PRODUCT/PROCESS CHANGE NOTICE (PCN)

ATTACHMENT I - PCN #: TB0605-05

PCN Type: Packing

Existing Shipping Tray

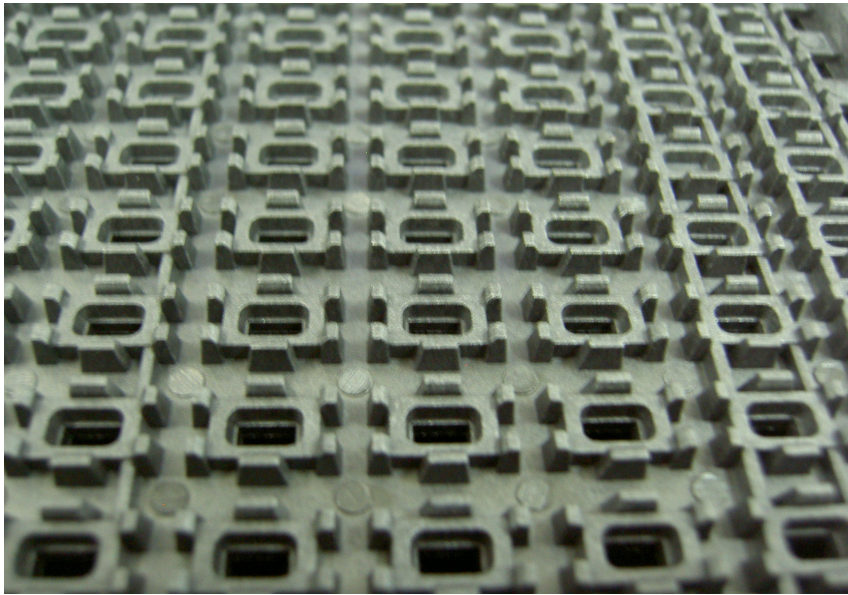
Detail of Change: This notification is to advise our customer that IDT has qualified new shipping trays for CVBGA 52L and 56L products. The new trays provide better protection during product shipment.

Please note that there will be a change in number of units per tray from 325 to 364 units/tray. There is no change in the tray dimensions.
